Docket Item #4  
BAR CASE# 2005-00239

BAR Meeting  
October 26, 2005

**ISSUE:** Alterations to previously approved plans

**LOCATION:** 1018 Queen Street

**Figure 1 - Proposed front elevation**

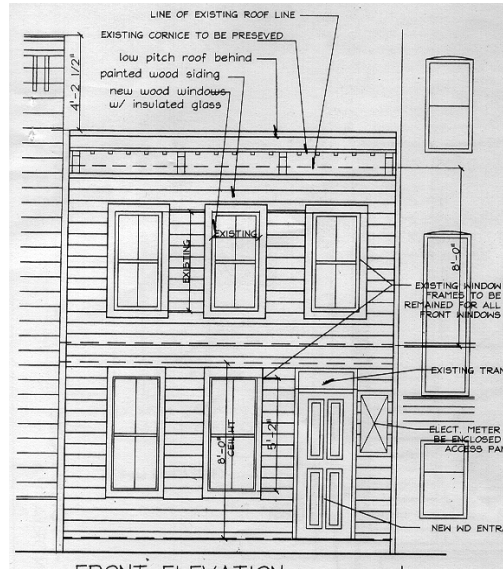
Front (north) elevation - The front facade will be returned to its original appearance. The original wood siding on the front of the house, now partially exposed under the bricktex siding, is an unusual variant of German siding. It has a bead in the scoop above the flat surface of the board and a reveal of approximately 5". Previously, the Board had approved retention of the original siding, *or replacement with a similar siding*. In view of the extensive after-the-fact demolition, the applicant has agreed that every effort will be made to retain the original front siding and that any replacement siding will be milled to replicate the existing, with Staff to

approve the replacement siding and the extent of replacement prior to installation. According to the applicant, the existing wood two-over-two windows will be replaced with new wood two-over-two windows with true divided lights manufactured by Kolbe and Kolbe. The new windows will be sized to fit the existing window openings. The applicant has confirmed that the existing window trim will be retained. The existing Italianate wood cornice will be retained. At the prior hearing, the Board expressed particular concern that care be taken to preserve this original feature. An extant transom above the door will be re-exposed. The electric meter will be enclosed in a box with access panel to the right of the door. According to the applicant, a single brick step will be added at the front entrance. Based on information provided with the prior application, the existing half light front door will be replaced with a new wood four panel door (Model #704 by JELD-WEN). A brass lantern style light fixture (Model Y38039-PVD by Hampton Bay) will be installed beside the door.

Staff believes these conditions should be repeated again with this approval. Furthermore, Staff recommends that to mitigate for the loss of the side and rear walls, the applicant should retain the existing unusual siding on the front facade to the greatest extent possible and repair only as necessary with new siding that replicates the original. Staff anticipates that this will require custom milling. The applicant has verbally agreed to this condition. Finally, in an attempt to ensure that there are no further misunderstandings, Staff has included a condition that the applicant seek Staff approval for any alteration to the approved plans. Lastly, Staff notes that the comments of Alexandria Archeology should again be included as a condition of the approval.

1. That the existing transom at the front door be retained;
2. That the existing window trim at the front be retained with the top and bottom trim matching;
3. The cornice be preserved;
4. The box to enclose the utility connections be approved by Staff;
5. That the existing front siding be retained and restored to the greatest extent possible with any replacement siding to be milled to replicate the original and Staff approve the replacement siding prior to installation;

**Figure 3** - Proposed south elevation

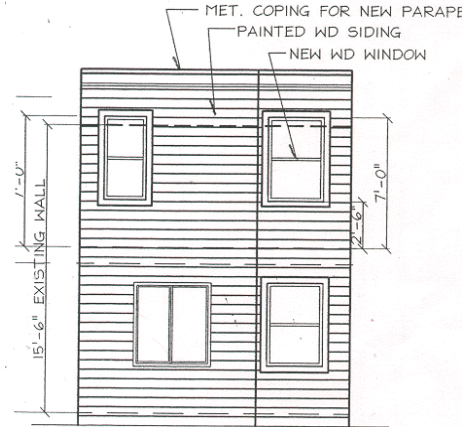
The rear wall of the main block and the ell will be clad in painted wood siding. The rear wall of the main block will have one-over-one wood windows on each floor. The rear wall of the ell will have the same, except that the window on the first story will be a casement.

The upper part of the rear wall of the ell is visible from the public alley at the rear. As the applicant proposes to replace the existing fence with a solid 6' fence, the lower portion of the house will remain obscured at the rear.
